World Forum for Harmonization of Vehicle Regulations

1958 Agreement – Consideration of draft amendments to existing Regulations submitted by GRSG

Proposal for Supplement 3 to the 01 series of amendments to Regulation No. 110 (CNG/LNG vehicles)

Submitted by the Working Party on General Safety Provisions*

Figure 1-1
Flow scheme for CNG and/or LNG components classification

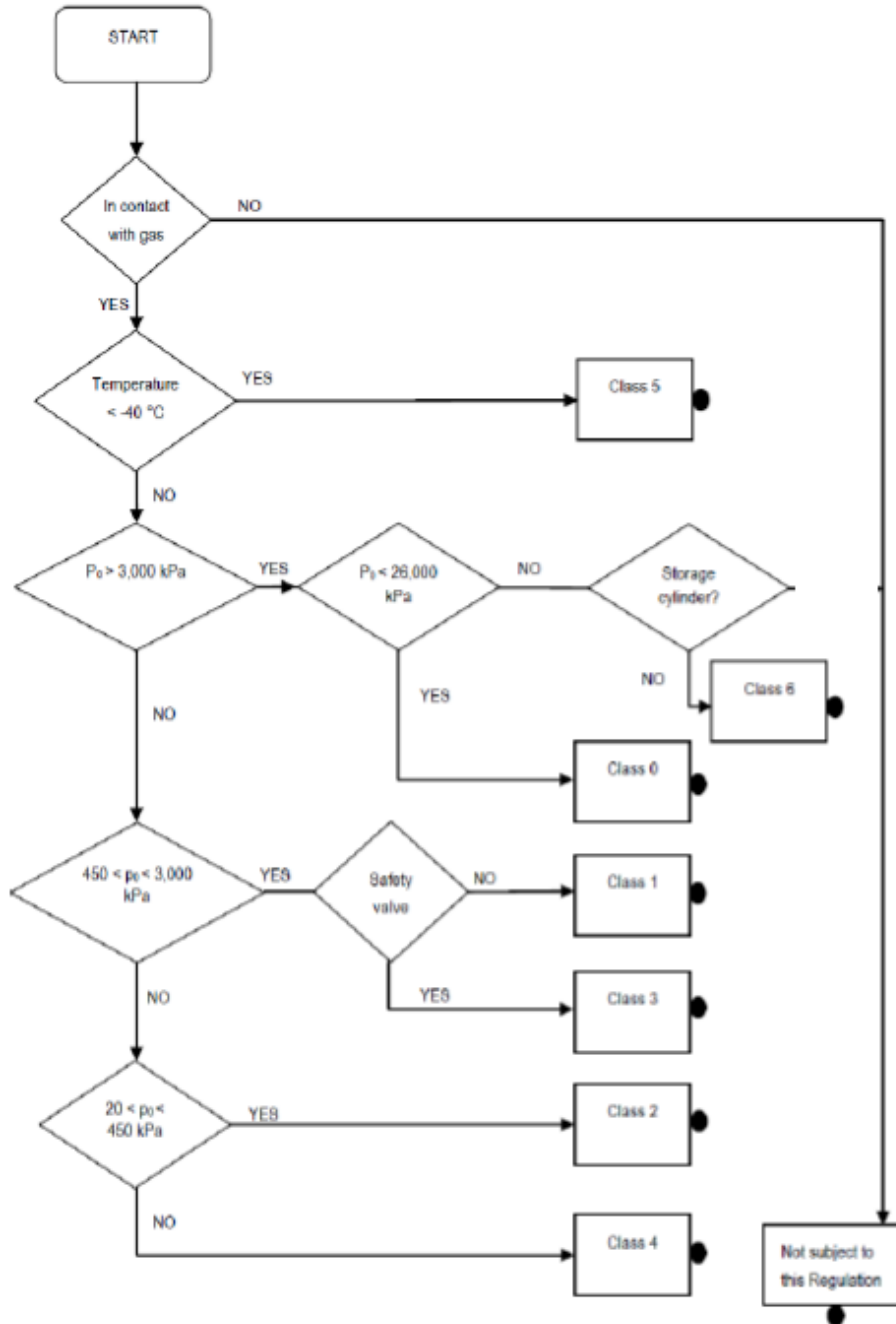
Paragraph 3., insert a new class and amend Figure 1-1 and Figure 1-2, to read:

Class 6 High pressure parts including tubes and fittings containing CNG, excluding CNG containers, at a pressure higher than 26 MPa.
